Woodbank House, Balloch Inspection Report

v01. 08/06/2017

This report should be read in conjunction with the Structural Inspection Report dated May 2017 prepared by Peter Brett Associates on behalf of TSL Contractors Ltd. For ease of reference the same numbering system as that used by the Structural Engineers has been adopted in this report.

Lichen and flaking masonry paint on stone pediment.

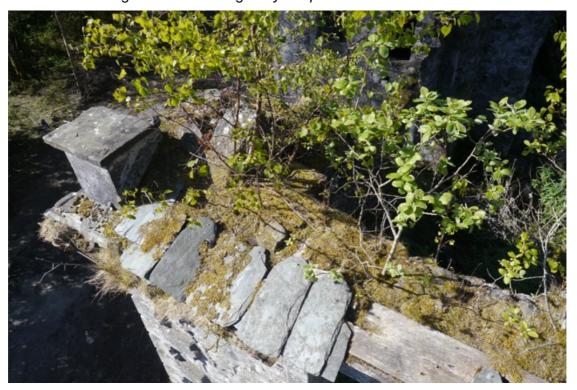
The surviving areas of finished store and render appear to have been coated with masonry paint. This is flaking off in many places and should be carefully removed to retrieve the fine detail of the stonework. Any surviving render should be stripped off anyway.

Above and below - vegetation, loose slates and damaged wallhead stonework - the timber boarding is the old sarking - any wallplate would have been set further back.

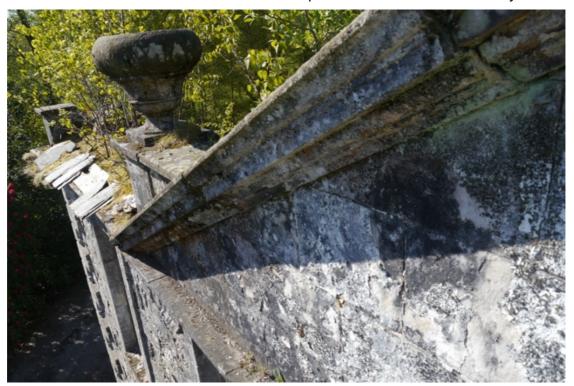
The Structural Inspection Report identifies the entire front wallhead as requiring replaced. The problem and the solution will be different along the eaves and along the base of the pediment. The eaves should be cleared of (extensive) vegetable growth, old slates and loose infill material to re-establish a horizontal wallhead. The detailing of this will depend on the shape of any new structure behind, however the wallhead should be rebuilt to the its original profile.

South-east corner and remains of south gable.

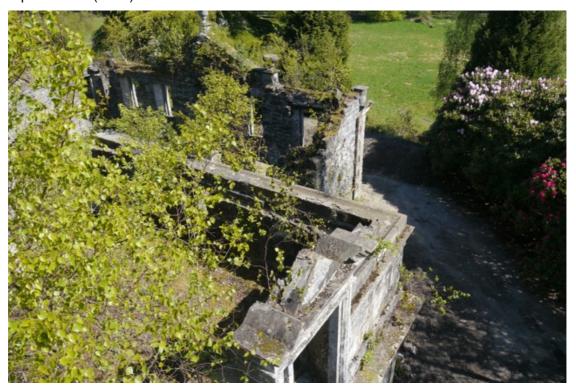
Old photographs show a steep roof to the original house, with high gables. What remains of this wall contains little of architectural value, including patch repairs in a variety of materials, including brick, block and cement mortar.

Nevertheless, there will be many strong reasons for rebuilding this wall in its original position, if not for its full height. These include:

- (a) providing lateral stability to a retained and repaired main elevation;
- (b) maintaining the architectonic link between the two main elements of the the structure, the east and south façades.

South elevation.

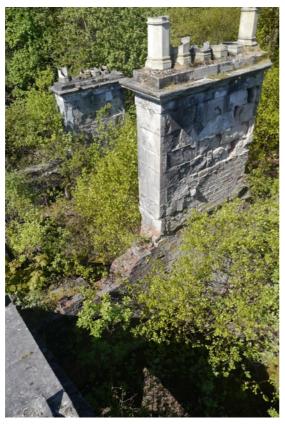
While the two central chimneys formed an intentional part of the original design of this elevation, their reinstatement could severly restrict options for the replanning of the building. It should follow that if the lost gable chimneys of the old house are not being replaced, then there should be no insistence on the replacement of the internal chimneys of the later extension. This should free up considerably the possibilities for the interior redesign.

Missing cope and dormer skew stones should be replaced in stone to match existing. Care should be taken detailing external finishes which may be visible above the parapets.

It appears form the detailing and the squared and coursed stonework that wall areas between the projecting dressed stone margins and string courses etc, may have been given a render finish. This should be investigated in greater detail as the detailing render to stone will be a key factor in restoring this elevation to its original appearance.

Above - vegetation growing off concrete second floor behind west gable.

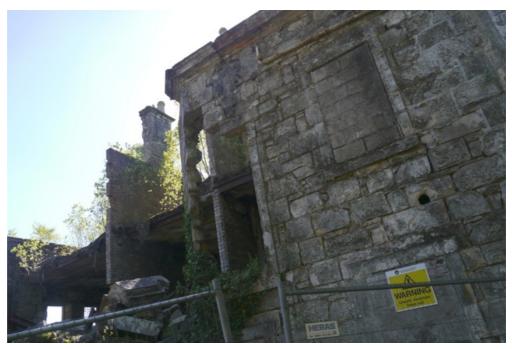
While this wall is less visible there are two reasons why it should be retained and the defective upper section rebuilt:

- (a) providing lateral stability to a retained and repaired main elevation;
- (b) the armorial plaque at second floor level is referenced in the building's listing.

The present positioning of the plaque would also point to the reconstruction of the gable chimney, which would also help give definition to the end of the building. Alternatively there may be scope for relocating the plaque elsewhere on the building, if this were acceptable to the planning authorities.

The gable wall is built of squared and coursed sandstone however it is difficult to tell whether it was originally pointed or rendered.
